Licence Number	L5275/1972/12
Licence Holder	Pilbara Iron Company (Services) Pty Ltd
ACN	107 210 248
Registered business address	Level 22 Central Park 152-158 St Georges Terrace PERTH WA 6000
Date of amendment	15 December 2016
Prescribed Premises	Category 5 – Processing or beneficiation of metallic or non-metallic ore; Category 6 – Mine dewatering; Category 12 – Screening, etc. of material; Category 52 – Electrical power generation; Category 64 – Class II putrescible landfill site; and Category 73 – Bulk storage of chemicals, etc.
Premises	Paraburdoo Iron Ore Mine and Eastern Range Project located within Tenements – AML70/246, L47/326, AG70/4, AG70/14 and AML70/4 MT ROCKLEA WA 6751

Amendment

Amendment Notice

Amendment Description

Figure 1. Location of monitoring bores around Paraburdoo landfill, bioremediation facility and TSF

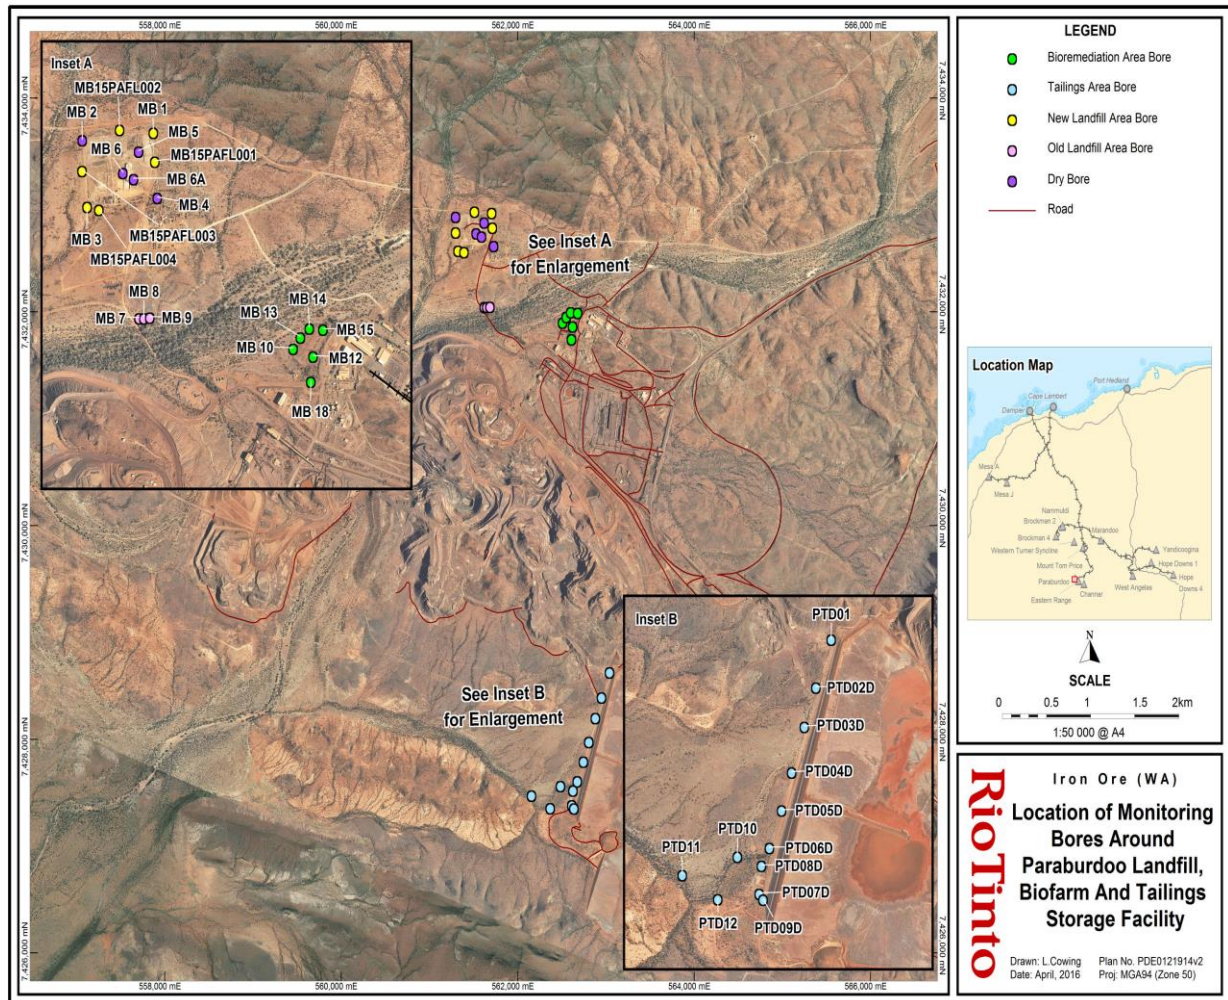
The Licence Holder has requested the removal of bore PTD01D located in Figure 1 below.

The Licence Holder indicates that the groundwater flows to the west. DER considers that the remaining bores around the TSF will adequately provide coverage to monitor seepage from the TSF. Table 1 of the Licence has been amended to remove bore PTD01D via this Notice.

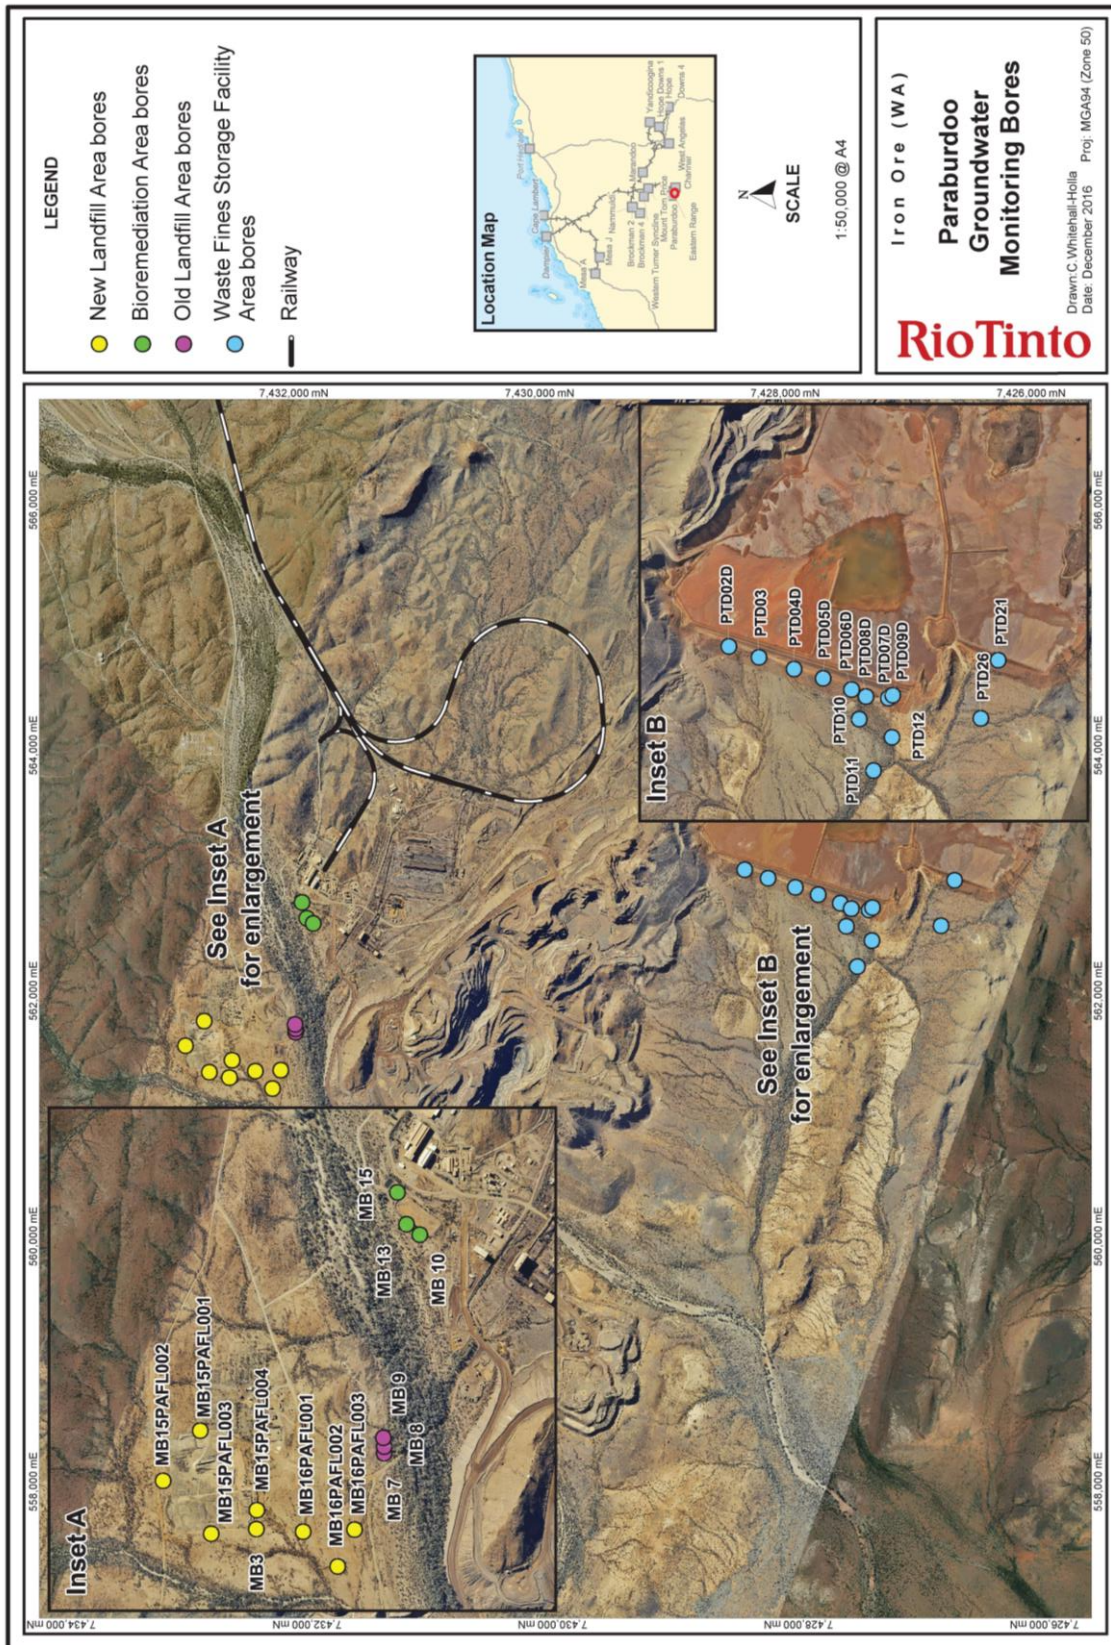
- Attachment 3 of the Licence is amended to include the location of the updated groundwater monitoring bores around the Paraburdoo landfill, bioremediation facility and TSF.
